HISTORIC AND DESIGN REVIEW COMMISSION

HDRC CASE NO: 2020-461
ADDRESS: 319 DELAWARE
LEGAL DESCRIPTION: NCB 3005 BLK 3 LOT 5
ZONING: R-6, H
CITY COUNCIL DIST.: 1
DISTRICT: Lavaca Historic District
APPLICANT: Julio Vazquez/Payaya Design & Build
OWNER: ROZMEN REBEL D & DIANA ONEAL
TYPE OF WORK: Installation of a rear accessory structure constructed from two shipping containers
APPLICATION RECEIVED: January 08, 2021
60-DAY REVIEW: Not applicable due to City Council Emergency Orders
CASE MANAGER: Rachel Rettaliata
REQUEST:

The applicant is requesting a Certificate of Appropriateness for approval to install a rear accessory structure constructed from two shipping containers.

Historic and Design Review Commission
Design Review Committee Report

Renderings

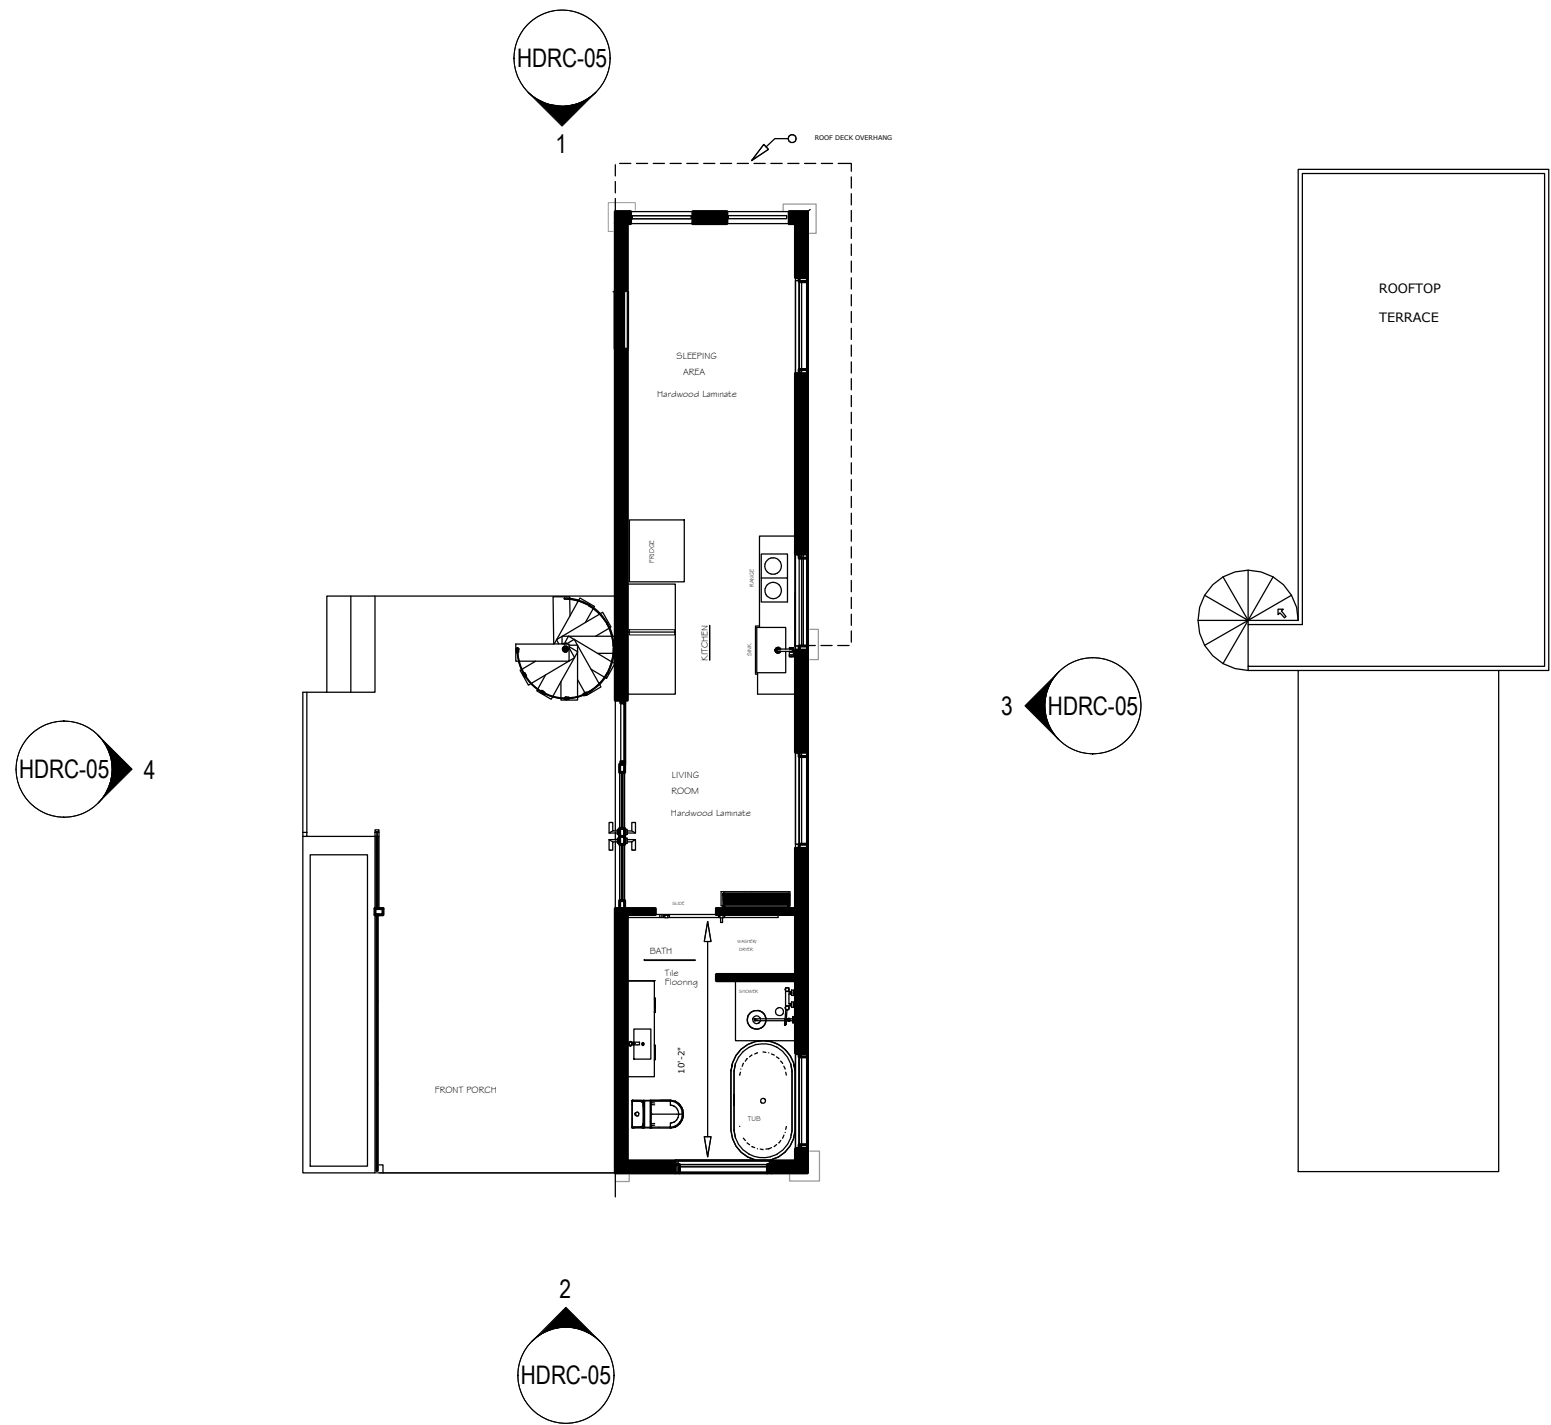
- i. **LANDSCAPING PLAN** - At this time, the applicant has not provided a landscaping plan. The updated application features renderings that show the installation of bamboo along the east elevation. The applicant should install bamboo at the rear of the structures as well to conceal the shipping containers from view of the neighboring properties and additional landscaping elements along the base of the front porch of the structure that are consistent with those found historically in the district.

- i. That the applicant submits final material specifications to staff for review and approval based on finding g.
- ii. That the applicant submits material specifications for the windows and doors to staff for review and approval based on finding f.
- iii. That the applicant provides an updated landscaping plan featuring bamboo installation at the rear of the structure and plantings along the base of the front porch based on finding i.

ELEVATIONS

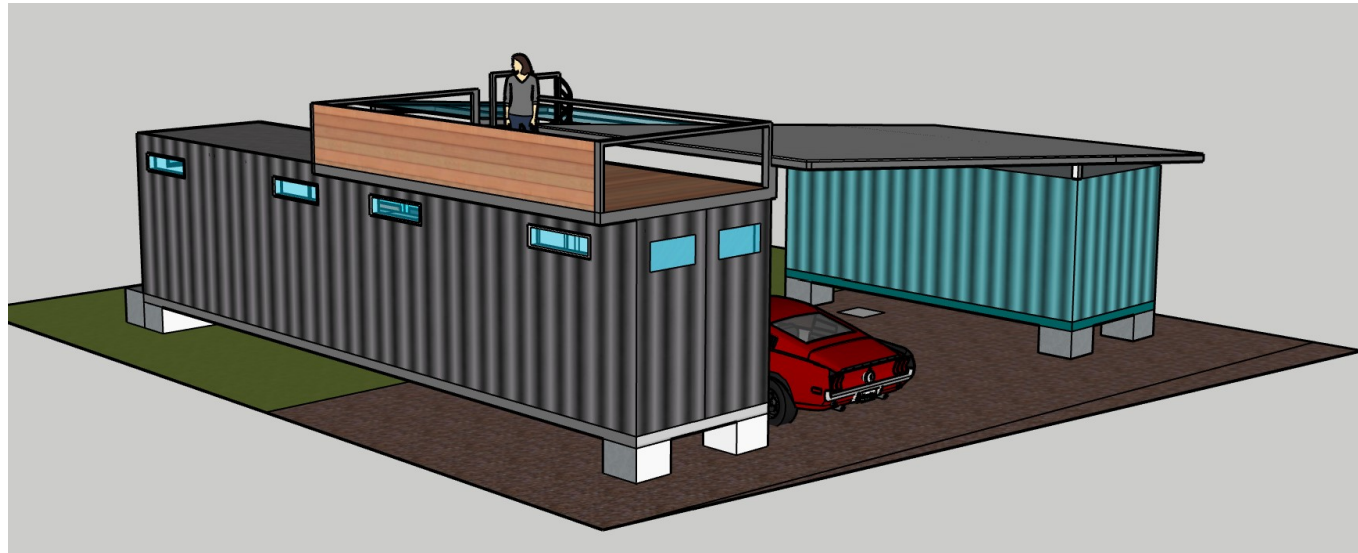
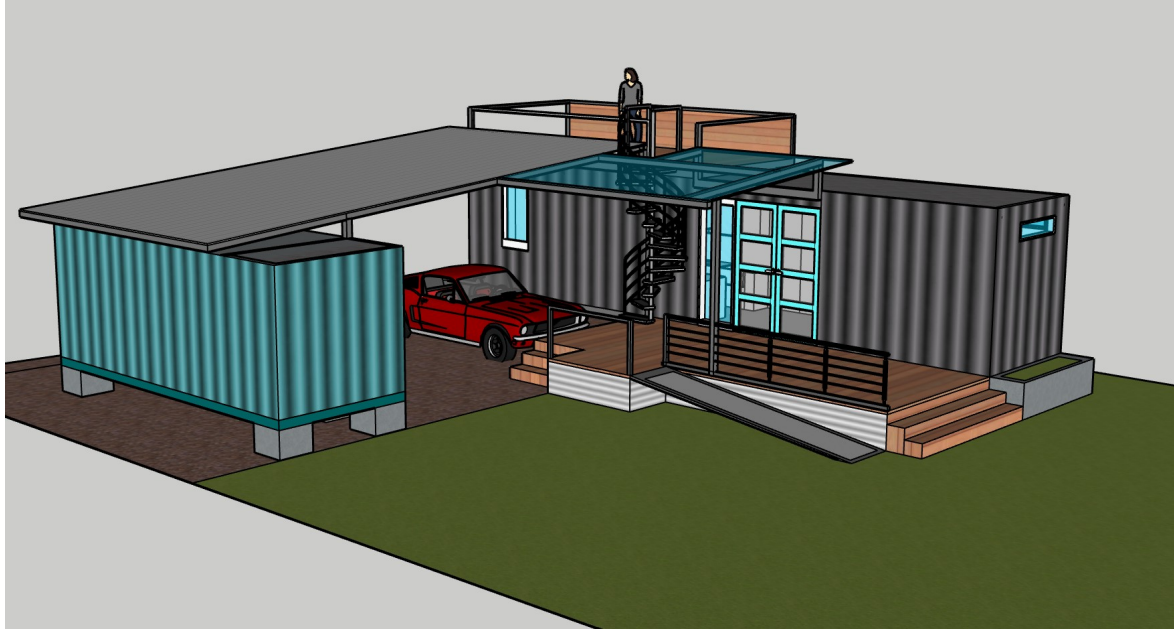
JF: The biggest elevation change is that the roof no longer connects the two structures?

JF: I see horizontal siding with a window

JF: Planting along the freeway side will alleviate some concerns

SC: I concur with Jeff's statement, these are most improved drawings. Solved my concerns with linking the elements together with one roof. I appreciate that this has been scaled down and the planting helps. Is it a necessity to have a ramp?

JV: Correct

JV: Part of the design change is to extend the door opening for the restroom, there is an extension and it will not be part of the container
